# PERMIT

## SEWAGE DISPOSAL SYSTEM

SUBDIVISION Indian Hill LOT 40 ROAD 12525 Howard Lodge Road

REPAIR - PURPOSE - SEPTIC SYSTEM HAS FAILED.

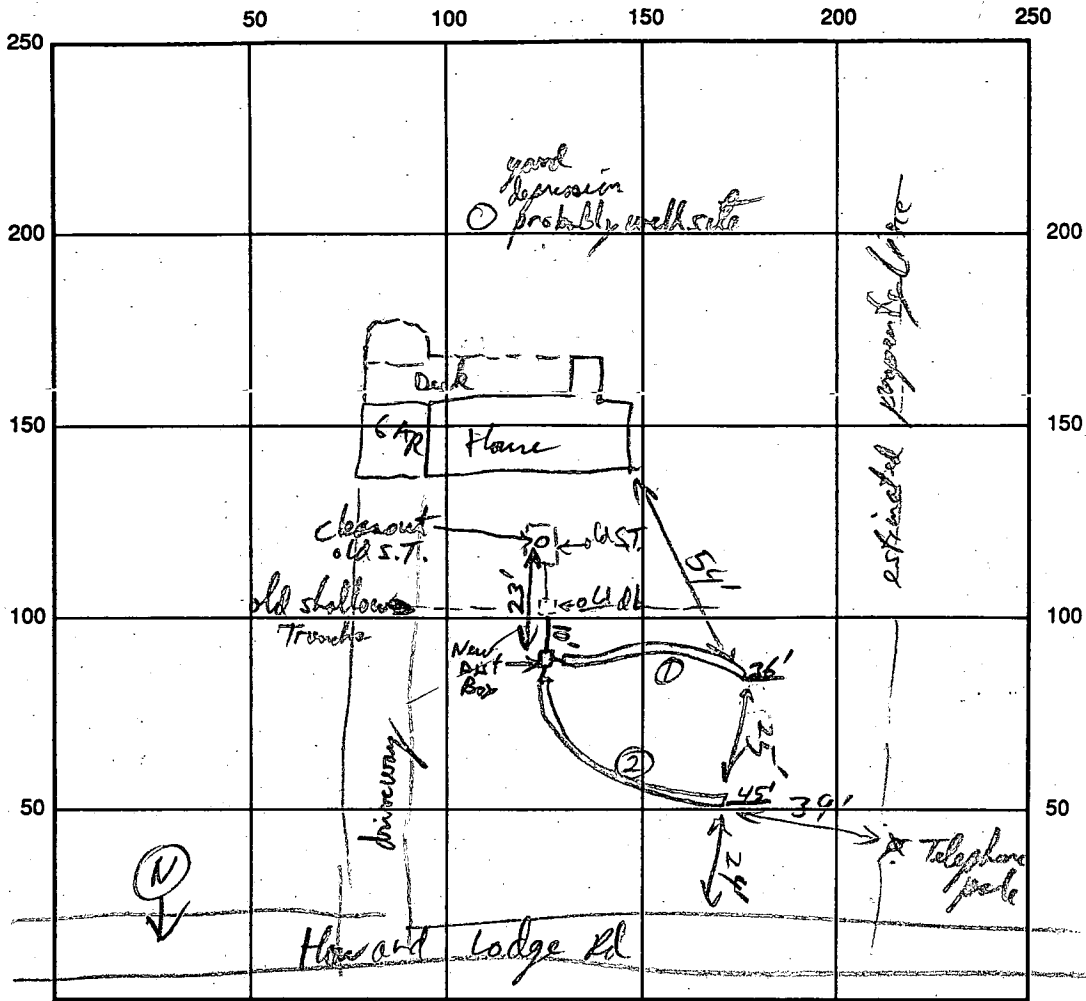
Call for inspection when ground is opened so sanitarian can recommend repair.  
12/12/94

I install 81 ft of trench, in lot at 3ft, 2ft wide, 9ft deep, 6ft stone fill.

SEPTIC TANK LEVEL existing 1000gal CLEANOUTS old S.T.  
 DISTRIBUTION BOX LEVEL New Level OK - still tied into old dist box  
 DRAIN FIELD/TITLE DEPTH 9' FT. TRENCH WIDTH 2 FT. INLET DEPTH 3 FT.  
 EFFECTIVE GRAVEL DEPTH 6' FT. TOTAL LENGTH 36/45 FT.  
 NUMBER OF TRENCHES 2 ONE SIDEWALL/BOTTOM AREA 486 SQ. FT.  $\frac{36}{2} \times 27 = 486$   
 DRYWALL INSIDE DIAMETER \_\_\_\_\_ FT. EFFECTIVE DEPTH BELOW INLET \_\_\_\_\_ FT.  
 ABSORBENT AREA \_\_\_\_\_ SQ. FT.

REMARKS: OK to cover trenches when finished, 12/20/94 JJP

**LOCATION CERTIFICATION**  
 #12525 HOWARD LODGE ROAD; LOT 40  
 "MAP OF INDIAN HILL"  
 HOWARD CO., MD. PLAT BOOK 9, FOLIO 75  
 DATE: 5/19/92 SCALE: 1" = 40' FILE: 13201

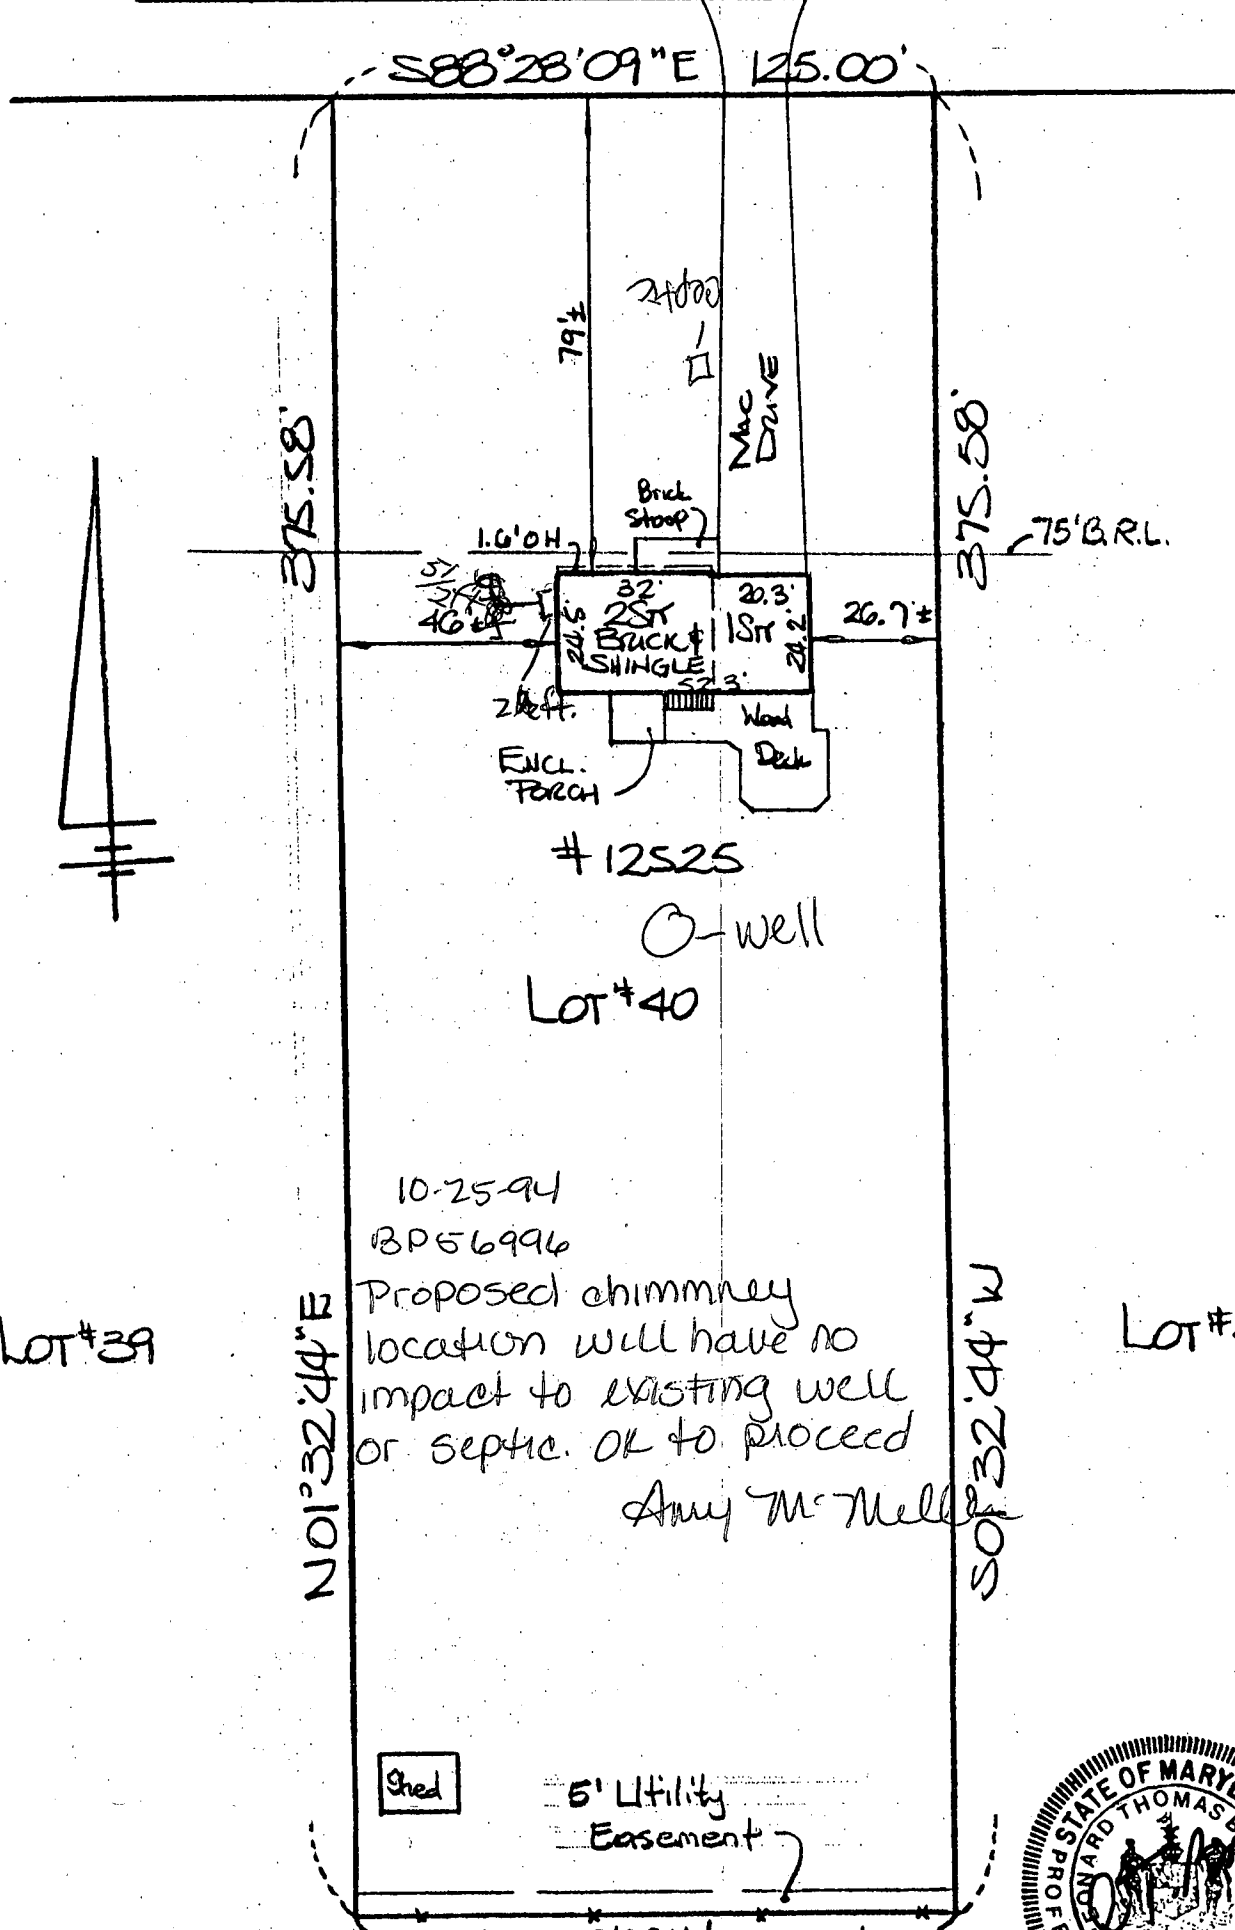
10-25-94  
 BP 66996  
 Proposed chimney location will have no impact to existing well or septic. OK to proceed  
 Amy McNeill
